**CHAPTER 6.0  
NON-GOVERNMENTAL ORGANIZATION AND LOCAL SPECIAL INTEREST GROUP  
COMMENTS AND RESPONSES**

**Table 6.1-1. Non-governmental organization and local special interest group comments received on the Oroville Facilities Relicensing Draft Environmental Impact Report.**

Figure 2. Percent Water Runoff at Oroville throughout 20<sup>th</sup> century.

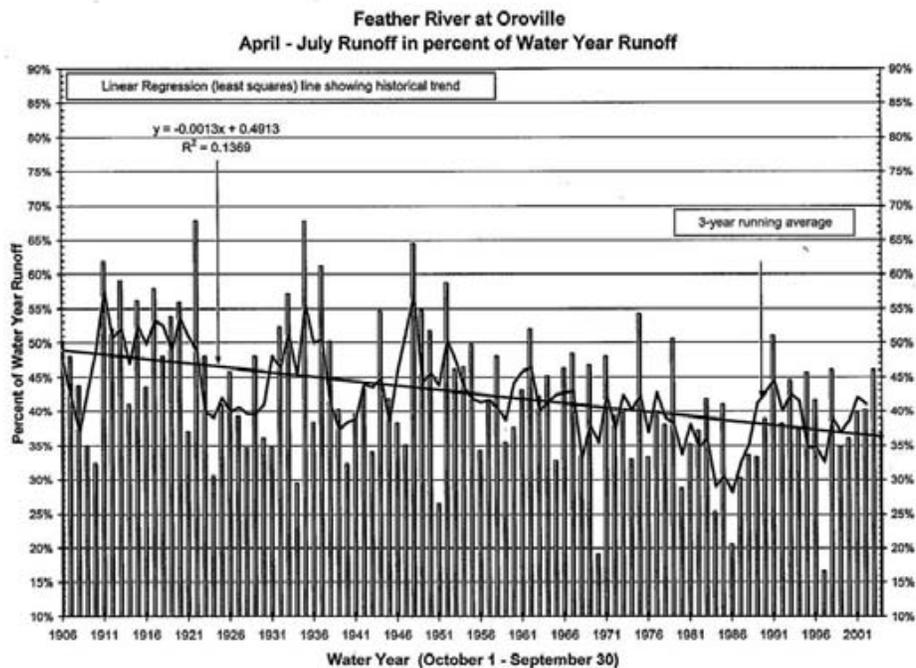
In anticipation of continuing trends in earlier seasonal snowpack runoff, the DEIR should model the project's reservoir operations and all alternatives under the range of temperature increase scenarios. Such analysis should quantify climate change effects on the ability of the Oroville Reservoir to provide adequate flood control and water supply, while completely maintaining the cold water pools available to sustain fishery habitat through the water year, even in the event of a flood emergency. DWR should also analyze whether the level of flood management available under a range of scenarios will support the standards for adequate flood protection downstream. Adaptive strategies necessary to decrease future flood risk evident in climate change model forecasts must be developed by projecting historical trends over a fifty-year span. (Figure 2)

N0008-12
